## DESIGN COMMISSION REGULAR MEETING AGENDA

# Design Commission Design Review

<b>Project No:</b>	DSR18-004
<b>Brief Description:</b>	Study Session
<b>Location:</b>	2856 80 <sup>th</sup> Ave SE Mercer Island WA 98040; Identified by King County Tax Parcel #5452300540
<b>Applicant:</b>	Scot Carr, PUBLIC47 Architects
<b>Staff Contact:</b>	Robin Proebsting, Senior Planner

Mercer Island Design Commission Study Session  
November 14, 2018

SECTION THROUGH SE 30TH STREET: OPTION 1 PROPOSED STREET DESIGN (PREFERRED)

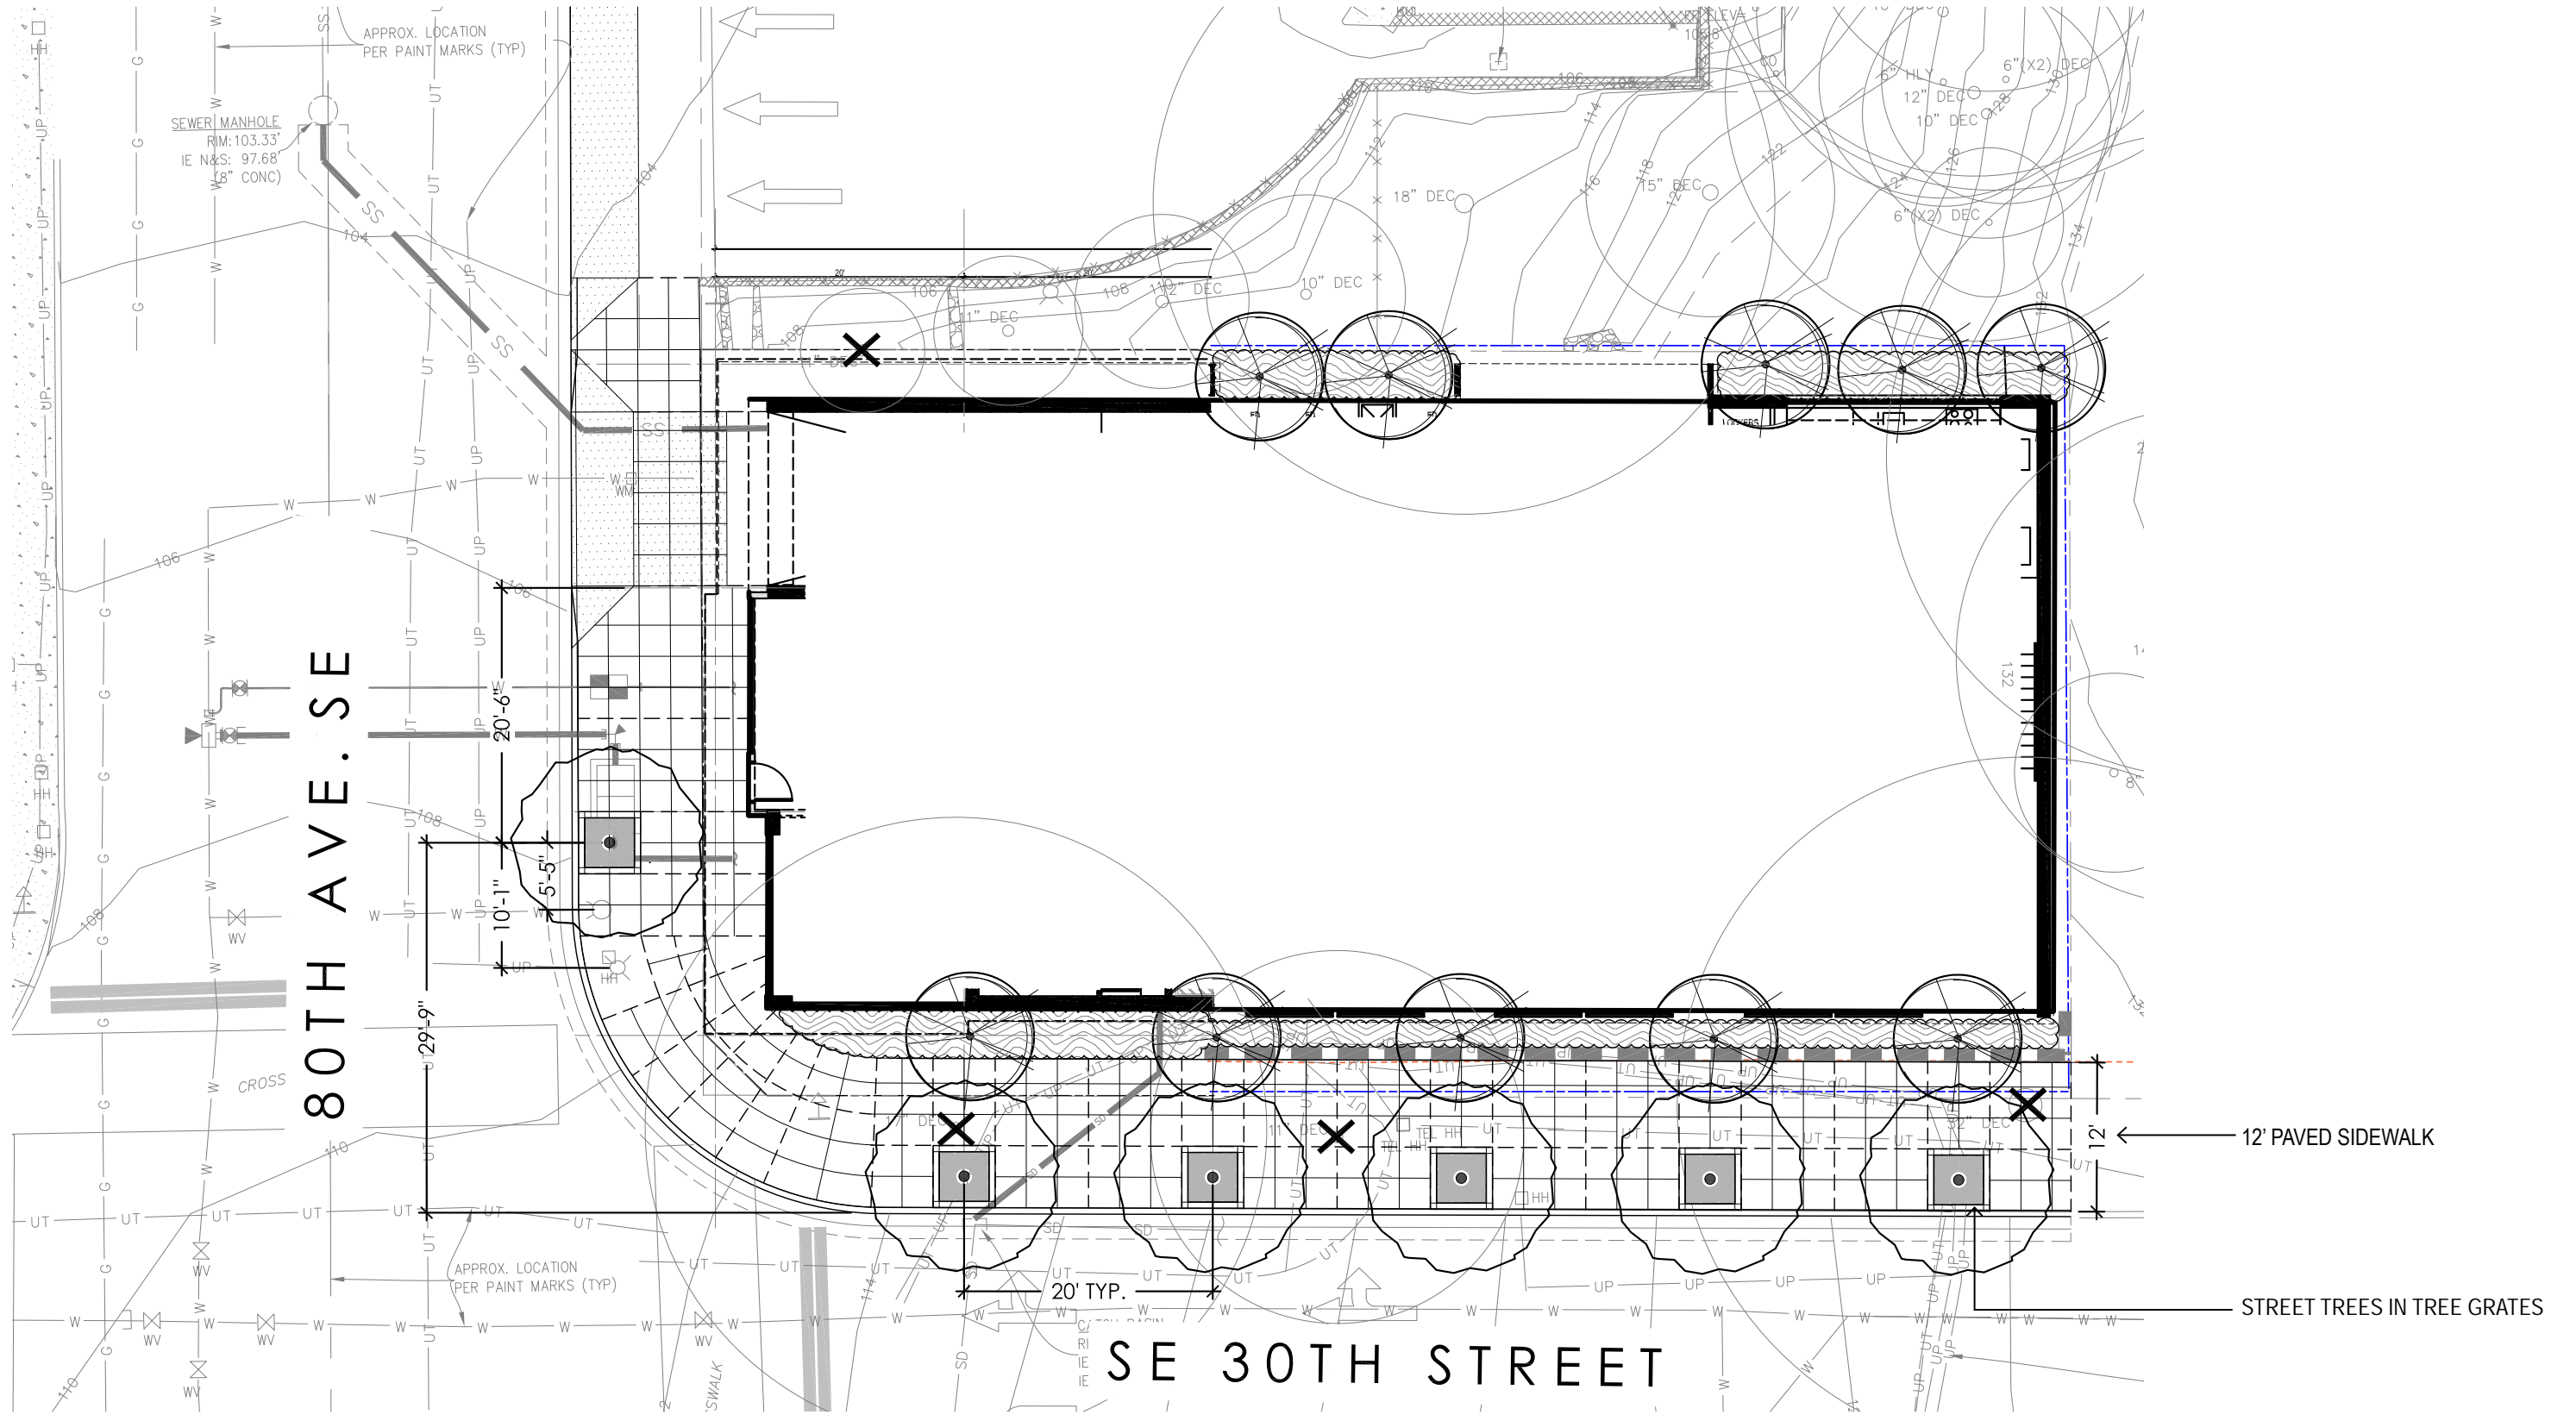
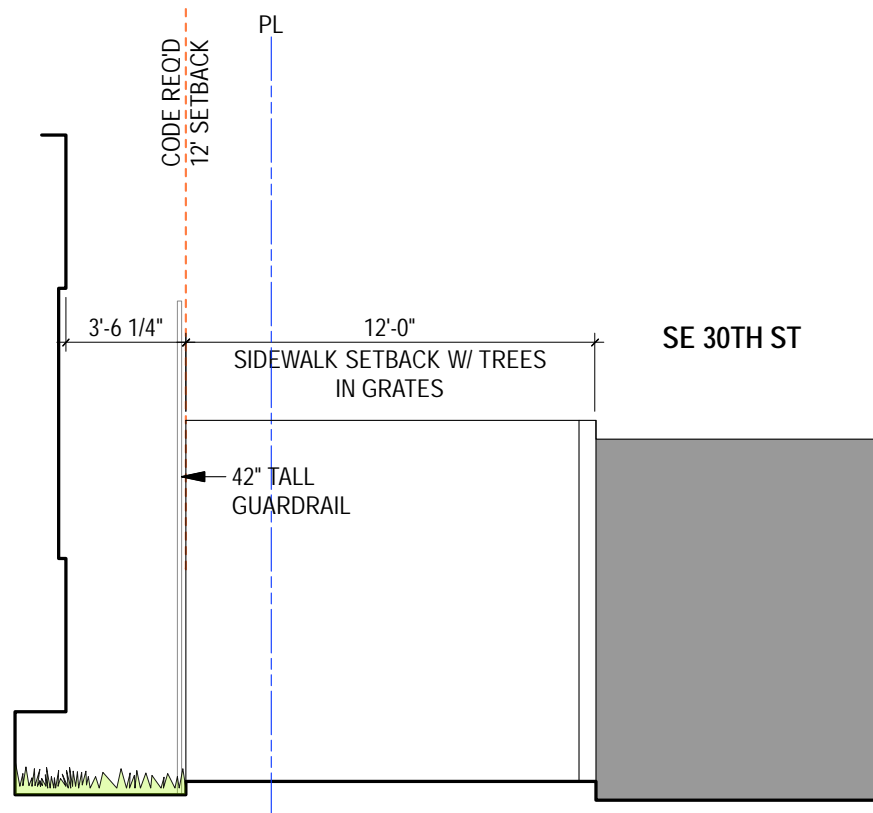
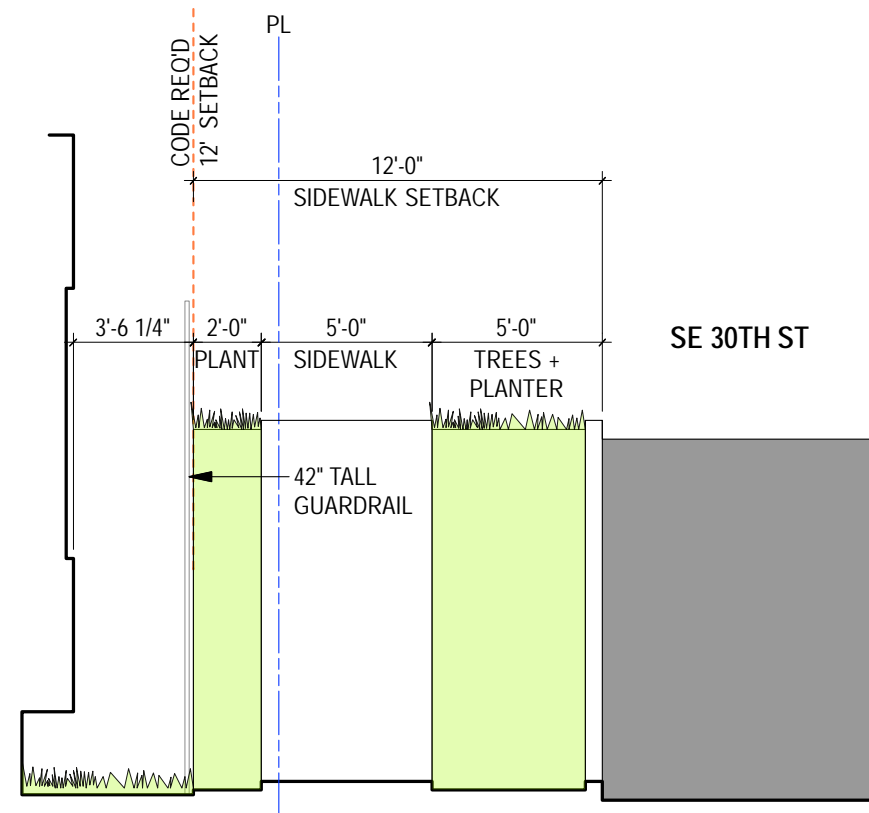
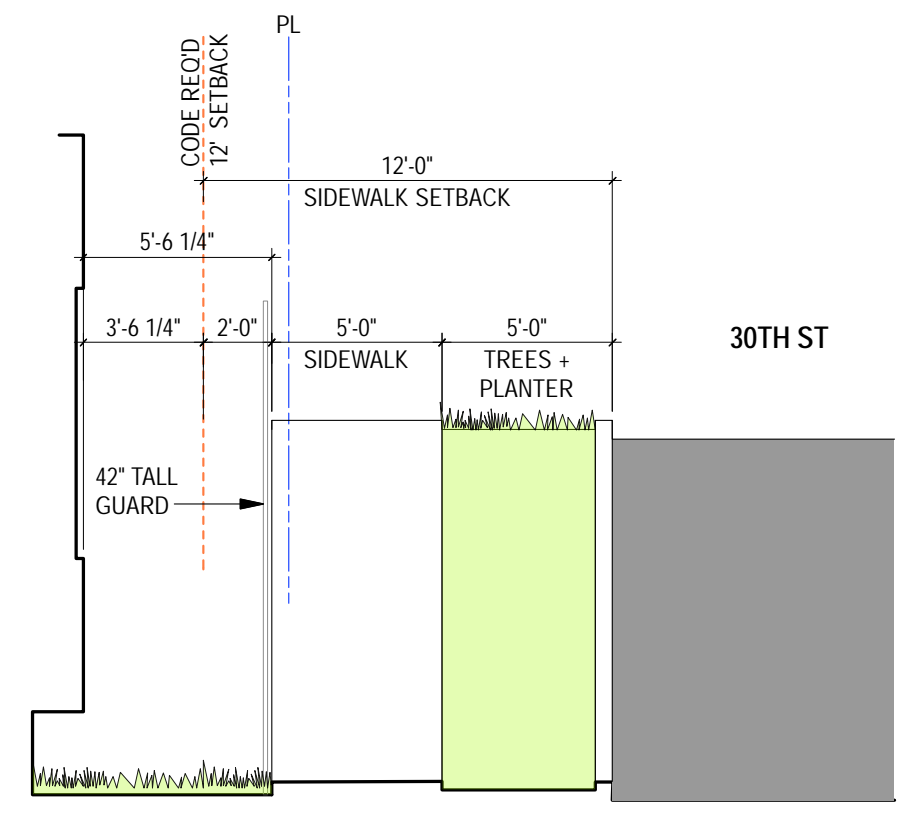
3. Applicant Question #3: Does the proposed streetscape design along SE 30<sup>th</sup> St meet the intent of MICC 19.11.120?

*One requirement of the Streetscape Manual is to provide street trees in tree grates along the street edge. The applicant has indicated that the site topography and abrupt end of the sidewalk qualify as unusual conditions and has requested a modification to the requirements of the street manual to*

provide: 1) a 5-ft wide planted strip instead of tree grates along SE 30<sup>th</sup> St and 2) a 2-ft planted strip on the building side of the sidewalk within the 12 ft sidewalk area (Exhibit 3, Sheet 18).

The requested modifications proposed to address potential challenges posed by the topography and abrupt sidewalk end by using landscaping to improve pedestrian safety. The 5-ft wide planted strip around the street trees would reduce the risk of slipping on metal tree grates, where the grade is 15%. The planted area also provides a buffer between the sidewalk and vehicular traffic on SE 30<sup>th</sup> St, enhancing pedestrian safety. Lastly, the additional landscaping and reduced sidewalk discourages pedestrian activity in an area where the sidewalk suddenly ends and no safe pedestrian crossing is provided. The City Engineer has indicated he would be supportive of a 5-ft sidewalk and increased landscaping.

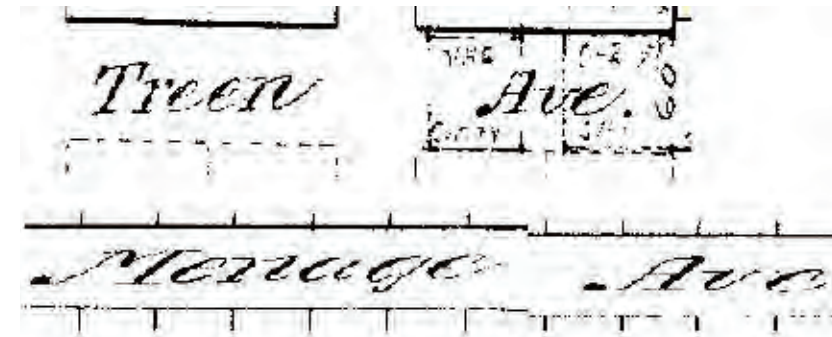
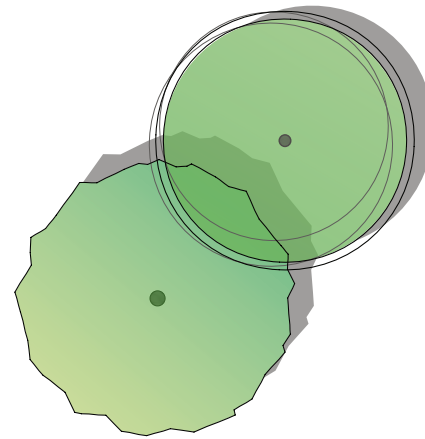
4. Applicant Question #4: Do the proposed Minor Site Features meet the intent of MICC 19.11.120 - Site Design?

**Staff analysis:** MICC 19.11.060 requires major new construction to have at least three minor site features. These may be, but are not limited to decorative features like clocks, artwork, drinking fountains, or other items that “create visual focal points that give identity to an area”. The code notes that the minor site features must “contribute to a well-balanced mix of features in that subarea as determined by the design commission.” The applicant proposes four minor site features: 1) custom tree grates, 2) inset bronze letters in the sidewalk displaying current and historic street names, 3) a custom stone slab bench, and 4) sporty bike racks (Exhibit 3, Sheet 20).

All four site features appear to fulfill in the intent and guidance provided in MICC 19.11.060(A). The tree grate would provide an artistic element integrated into required site infrastructure, consistent with the examples of decorative landmarks provided in the relevant code section. The bronze lettering would provide identity to the site and highlight the site’s unique history in the context of Mercer Island, integrated with the public street improvements as encouraged by the code. The stone bench provides usable street furniture and would be congruent with building design, as described by code standard. Lastly, the proposed bike rack would provide bike parking in an area where little is currently provided, contributing to a well-balanced mix of features in the TC-3 subarea.

VIEW LOOKING SE

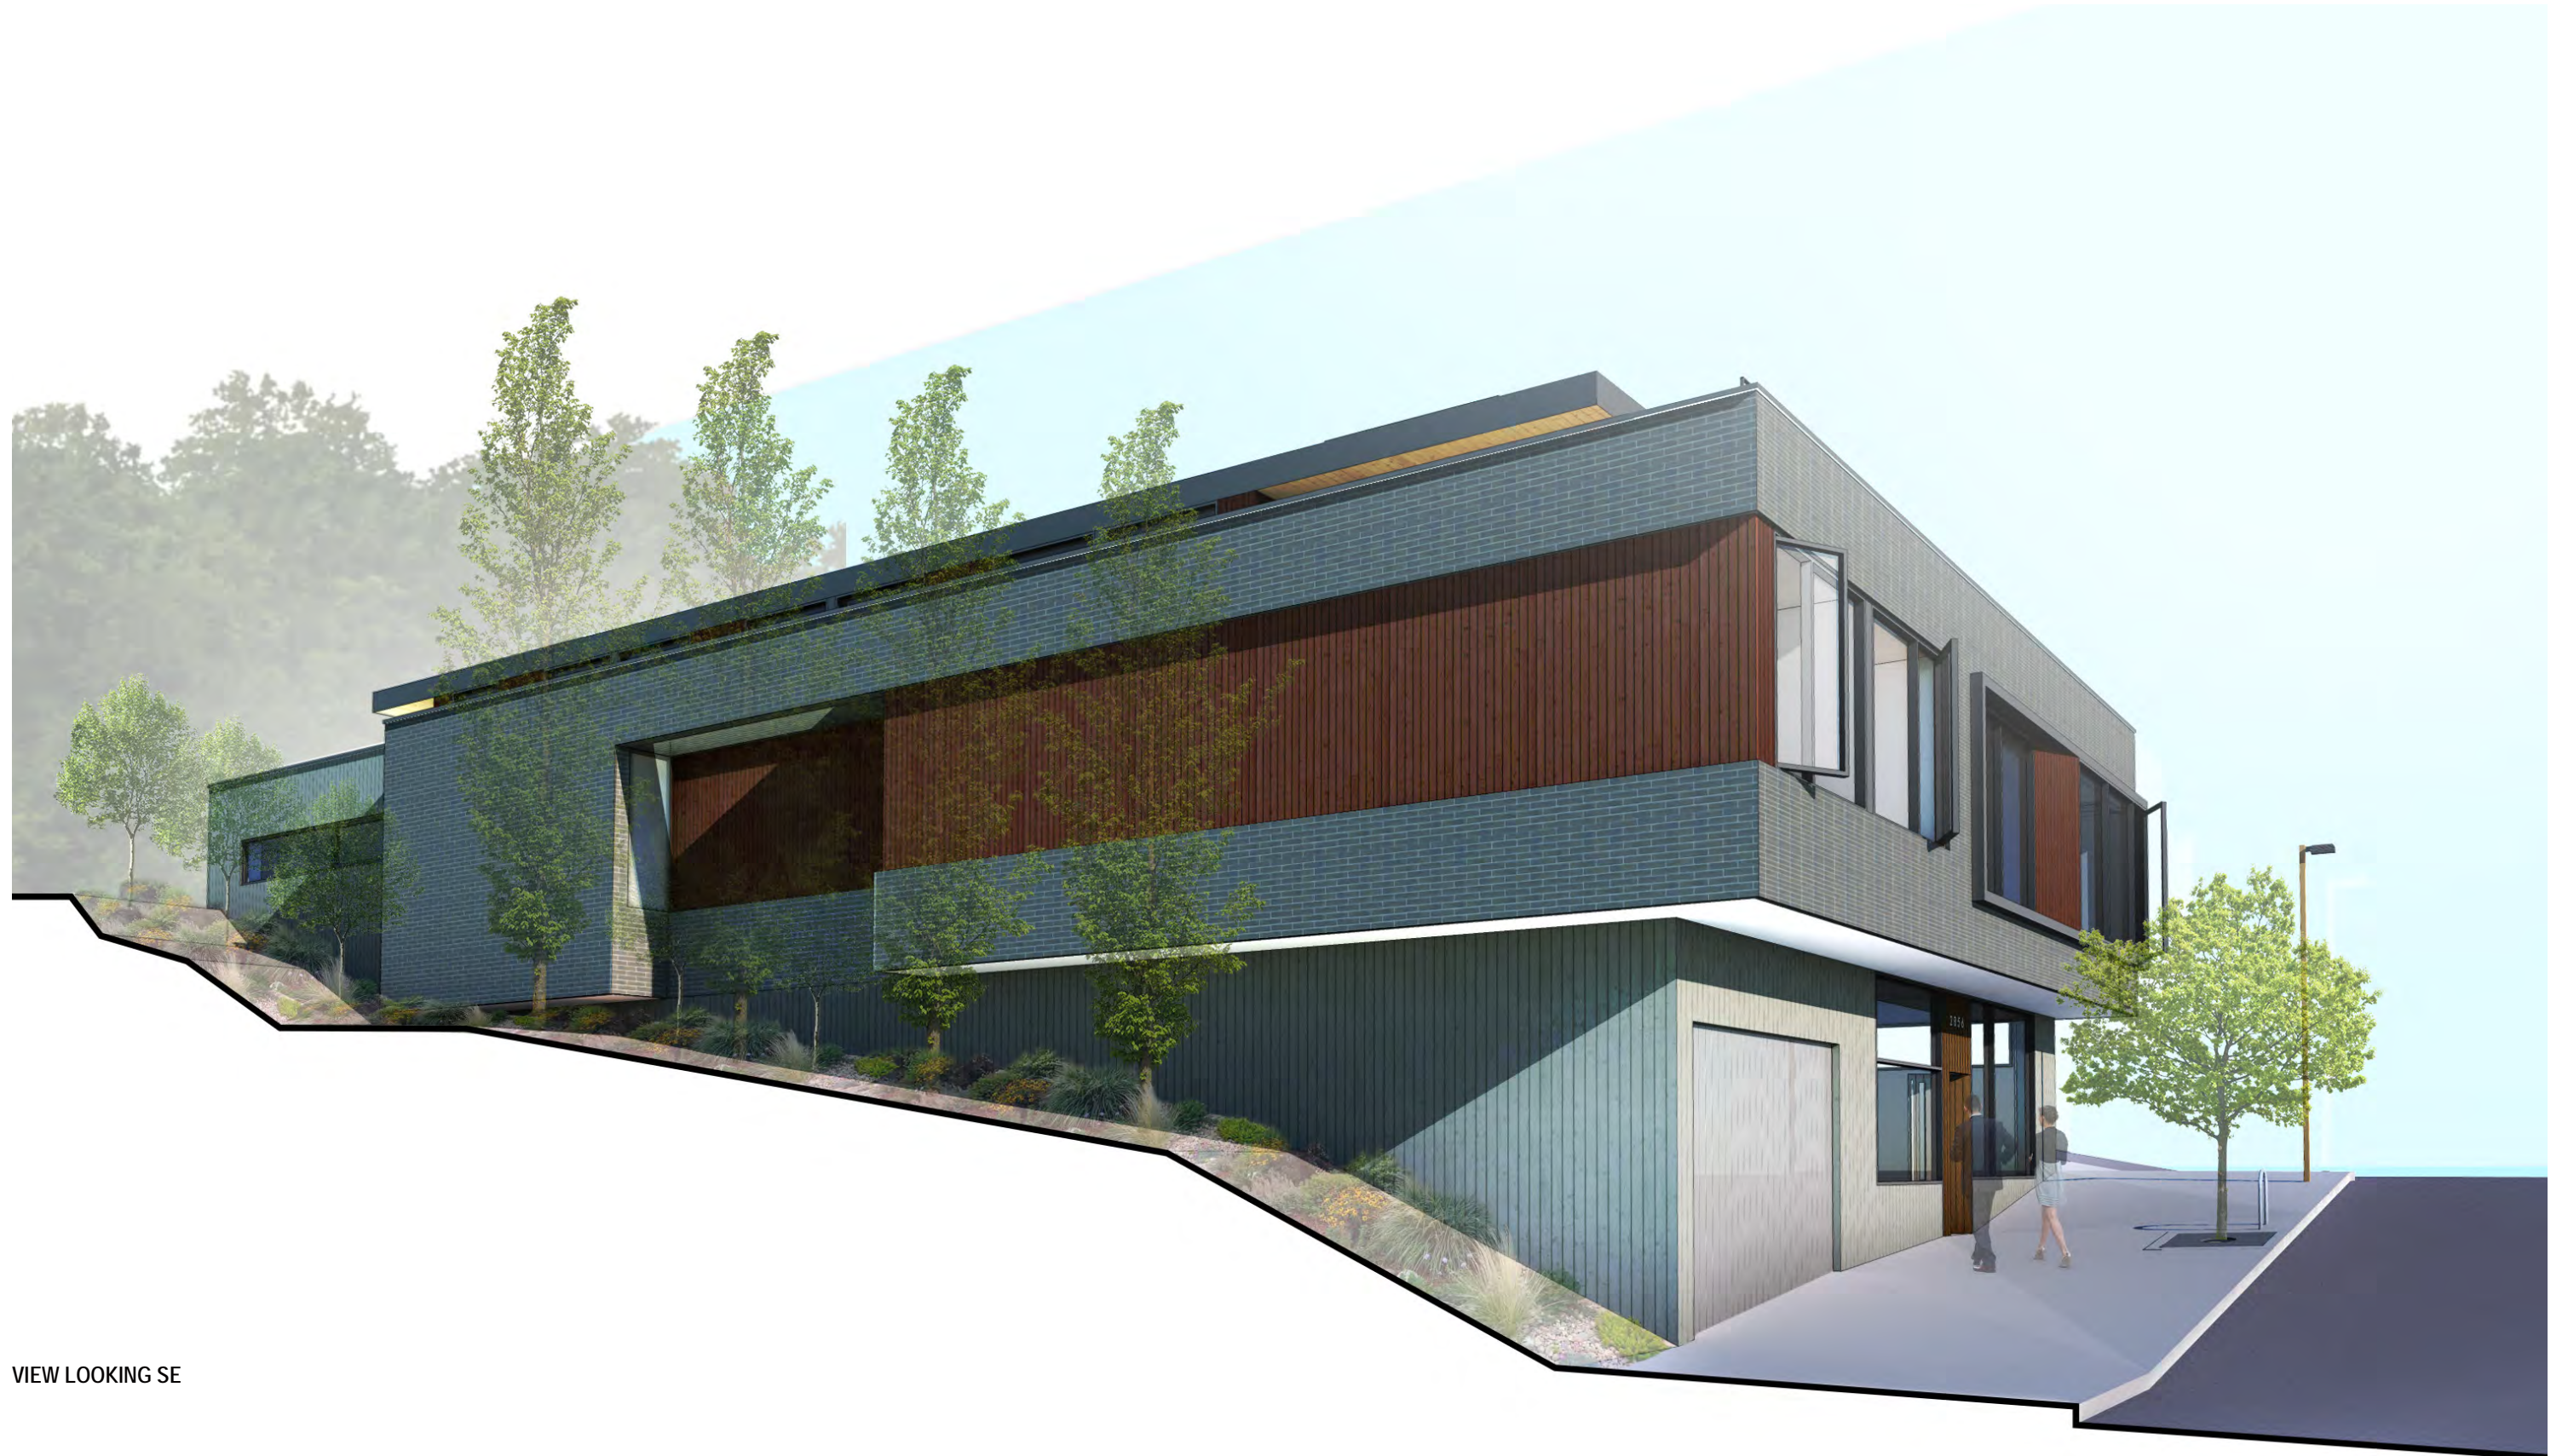
5. Applicant Question #5: Does the proposed design of north wall meet the intent of MICC 19.11.100 - Walls?

**Staff analysis:** Untreated blank walls, defined as wall over six feet in height and with a horizontal length greater than 15 feet that does not include a transparent window or door, are prohibited by MICC 19.11.100(B)(5). Methods provided by the code to treat blank walls include building detailing that adds visual interest at a pedestrian scale as approved by the design commission. Such building detailing must use a variety of surfaces and not be a monotonous design.

To meet this standard for the north wall, the applicant proposes to use the same mix of building materials proposed for use on the other building elevations and to landscape around the perimeter of the building. There is a portion of the north façade on the second level of the building that is roughly 17 ft in height by approximately 20 ft in width, larger than the size allowed by code to be a blank wall. This portion of the building proposes to use brick, which would provide a patterned, textured surface, meeting the standard in MICC 19.11.100(B)(5)(e) (Exhibit 3, Sheet 22).
